Re: **RESUBMISSION** – 176 Virginia Road, North White Plains
(S/B/L: 122.16 – 1 – 3. Zone District: “IND-A “

**PRIOR BOARD APPROVAL – RESOLUTION DATED 4/25/22 (SIGNED 4/29/22)
(COPY ATTACHED)**

Action:	Site Plan, Steep Slope and Tree Removal Approvals
Application Name:	Mistis Properties 100 Inc. [2021-017]
Applicant/Owner:	Mistis Properties 100 Inc.
Designation:	122.16-1-3
Zone:	IND-A Zoning District
Acreage:	0.38 acres
Location:	176 Virginia Road
Date of Approval:	April 25, 2022
Expiration Date:	April 25, 2023 (1 Year)

REINFORCED CONCRETE WALL WITH ARMORED SLOPE DETAIL
 SCALE: 1/4"=1'

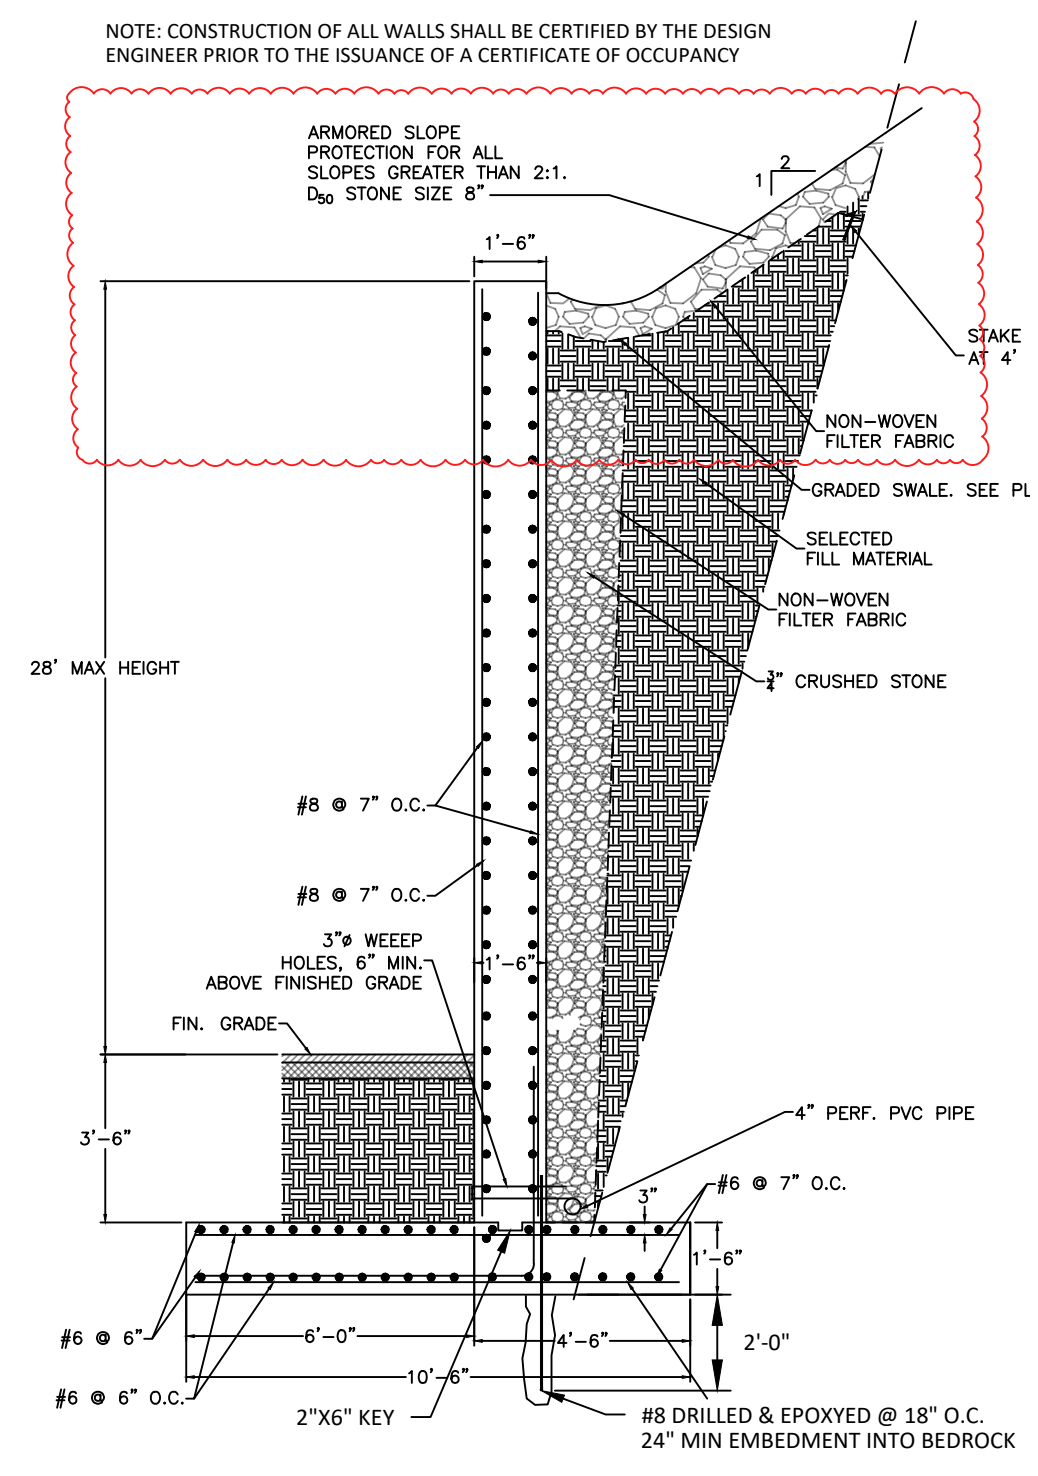
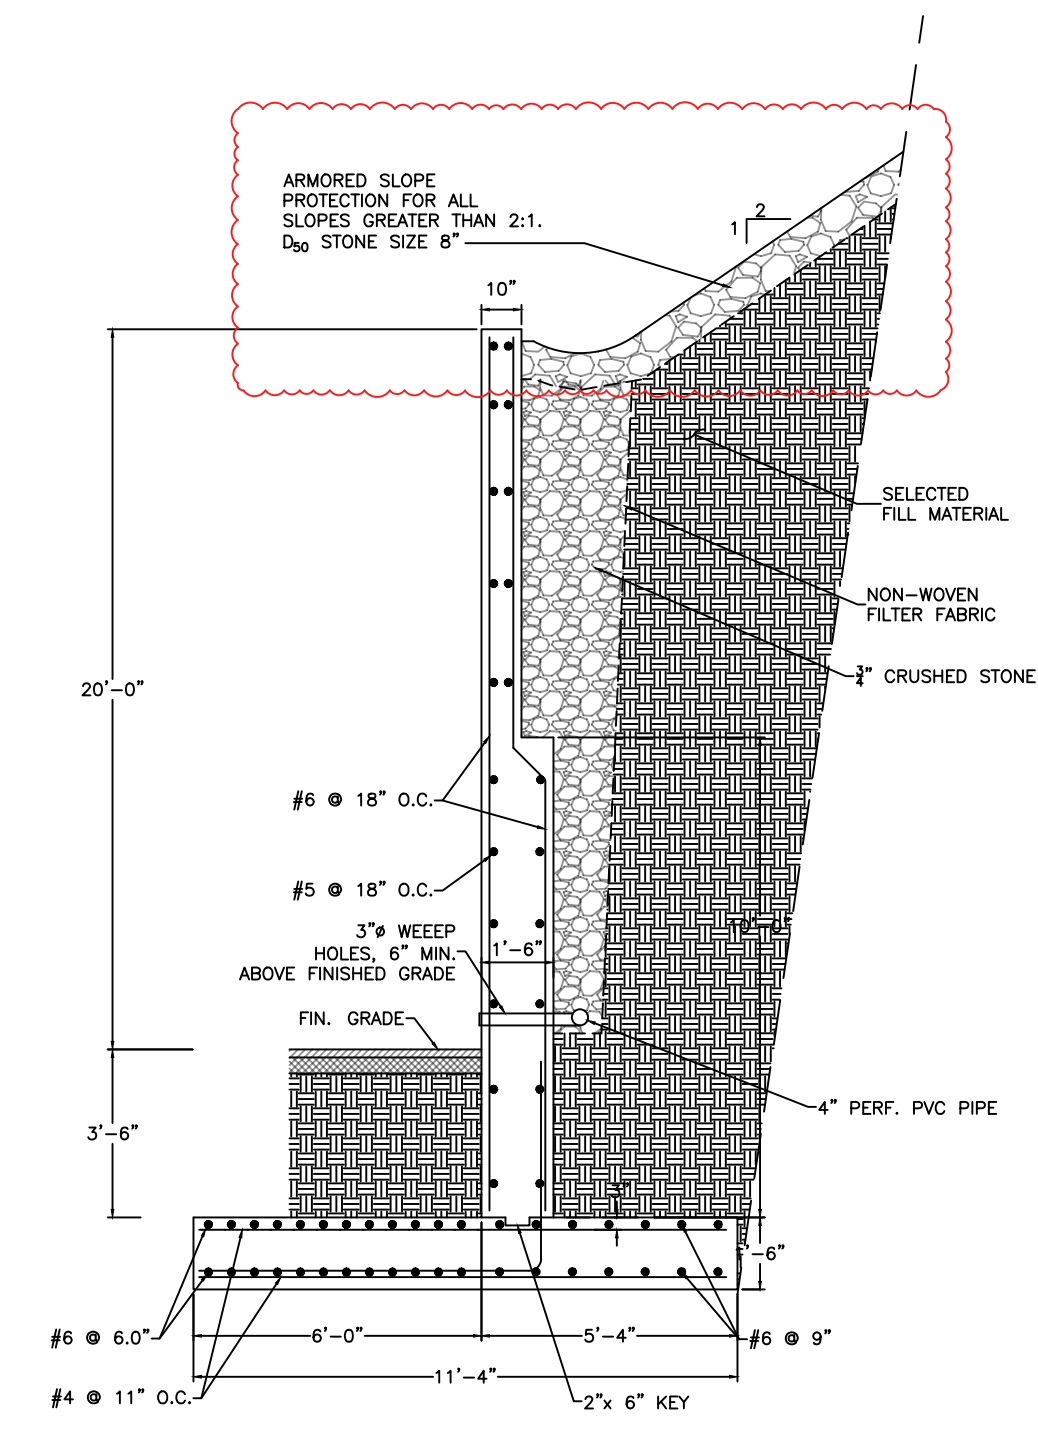
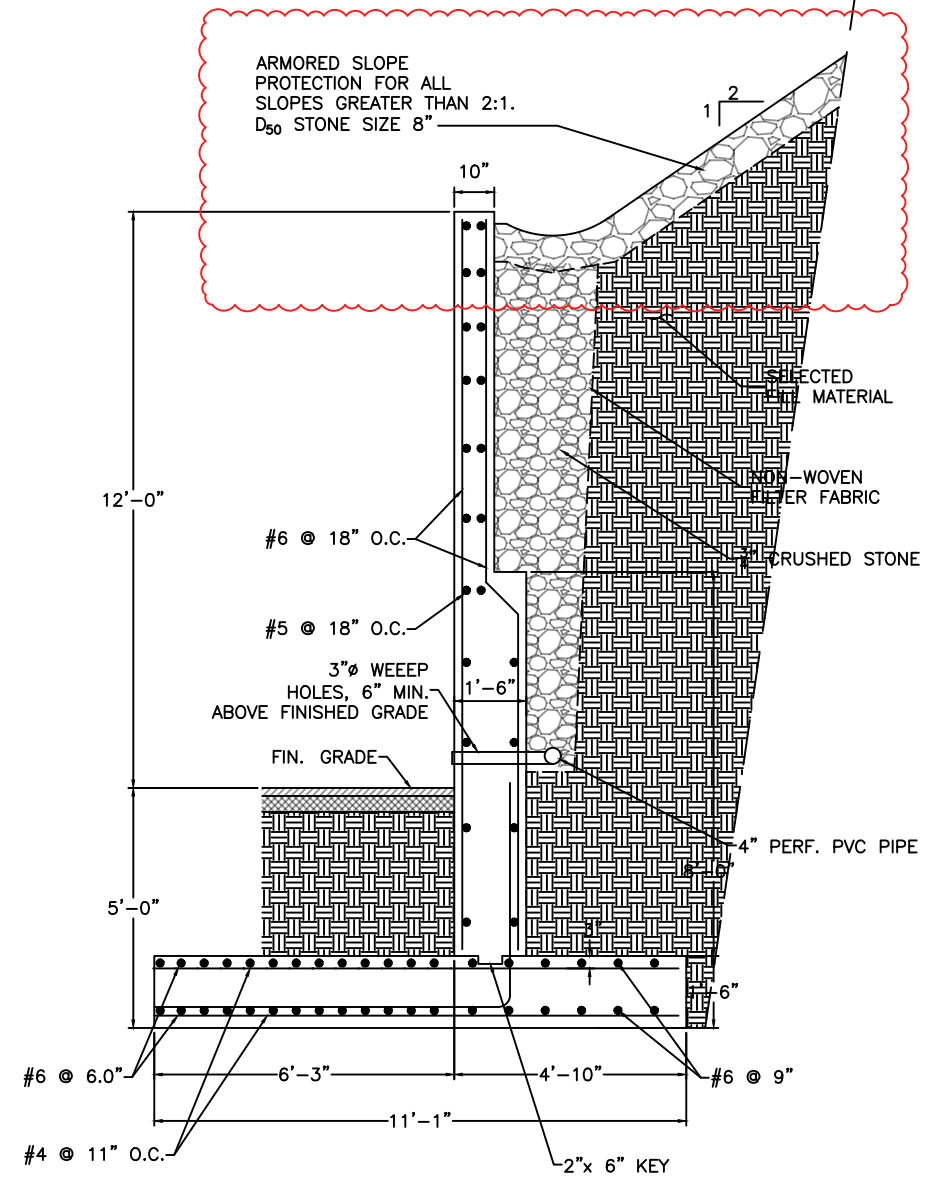
1. The plan requires a retaining wall along the rear and sides of the property with a maximum height of approximately 28 feet. For clarity, the proposed retaining wall shown on the grading plan shall include top of wall and bottom of wall elevations at each change in elevation to be coordinated with the elevation changes shown in section provided on Sheet S-7. The plan shall also illustrate the required grading of the slopes above the retaining wall necessary to maintain the proposed 1V:2H slope and include a detail of the armored slope referenced in the typical retaining wall sections.

1. The plan requires a retaining wall along the rear and sides of the property with a maximum height of approximately 28 feet. For clarity, the proposed retaining wall shown on the grading plan shall include top of wall and bottom of wall elevations at each change in elevation to be coordinated with the elevation changes shown in section provided on Sheet S-7. The plan shall also illustrate the required grading of the slopes above the retaining wall necessary to maintain the proposed 1V:2H slope and include a detail of the armored slope referenced in the typical retaining wall section.
Plans were updated as per comment. (See Retaining Wall Section on Sheet S-7.)

- _____ 5. The top-of-wall elevations along the length of the proposed retaining wall shall be verified to the satisfaction of the Town Engineer. It is not clear how proposed steps/grade changes will be addressed with the wall height. As shown, there are sections of the proposed wall that are several feet below the adjacent retained soils. Final slopes and required grading above the wall shall be illustrated, as well as stabilization measures. **ALIGNMENT ALONG TOP OF WALL PROFILE INCLUDED ON SHEET 7 OF 7**

NOTE:
 RETAINING WALL DESIGN CALCULATIONS, PREPARED BY A NYS LICENSED PROFESSIONAL ENGINEER, SHALL BE SUBMITTED PRIOR TO THE ISSUANCE OF A BUILDING PERMIT. THE CONSTRUCTION OF ALL RETAINING WALLS SHALL BE CERTIFIED BY THE DESIGN PROFESSIONAL.
